Item Name: Replacement Skidtube (Fits LH or RH)

DRAWING NO. D2650	TITLE 206/407 SKIDTUBE ASSEMBLIES	REV. F	DART AEROSPACE LTD ENGINEERING ORDER		D.E.O. NO. D2650-F-1	SHEET NO. SHEET 1 OF 1	SCALE NTS
DRAWN <i>[Signature]</i>	CHECKED A.P.	MFG. APPR. <i>[Signature]</i>	APPROVED <i>[Signature]</i>		DE APPR. <i>[Signature]</i>		
DATE 12.10.12	DATE 12.10.22	DATE 12.10.22	DATE 12.10.22		DATE 12.10.22

CHANGE C'BORED WELDED CROSSBOLT SPACERS TO SWAGED SPACERS

AMENDMENT TO DETAIL B
NOT TO SCALE

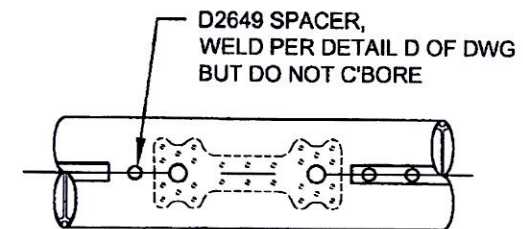
ADD DETAIL G BELOW, WHICH IS THE SAME SECTION VIEW AS DETAIL D OF DWG.
C'BORED HOLES ARE **NOW SWAGED** PER DETAIL G BELOW. FOR THE Ø0.375 HOLE THAT IS NOT C'BORED, WELD PER DETAIL D OF DWG (SEE AMENDED DETAIL B FOR REFERENCE).

DETAIL G

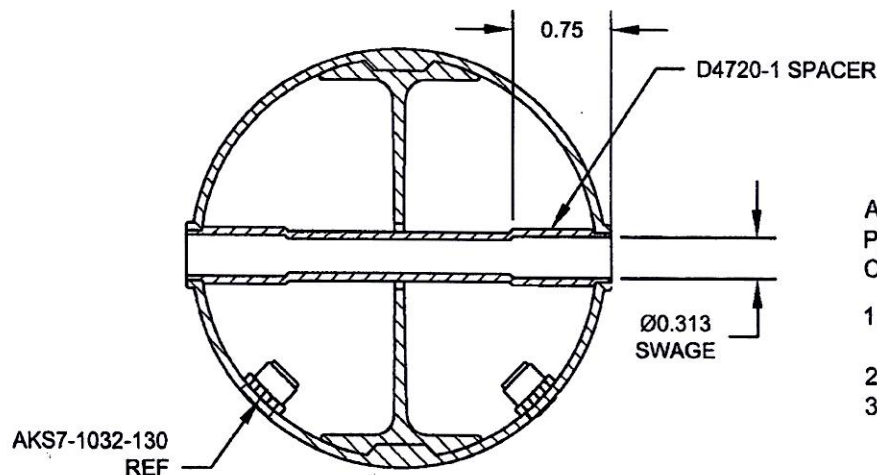
FOR Ø0.375 HOLES ONLY
FOR HOLES THAT ARE CURRENTLY C'BORED ONLY
NOT TO SCALE

AFTER DRILLING AND BENDING ASSEMBLY
PERFORM THE FOLLOWING FOR Ø0.375 HOLES THAT ARE
CURRENTLY C'BORED:

1. INSERT D4720-1 SPACER, 16 PL (-1) OR 17 PL (-3)
OR 19 PL (-5) OR 23 PL (-7)
2. SWAGE TO Ø0.313 X 0.75 DP PER QSI 002
3. TRIM / GRIND FLUSH PER QSI 002
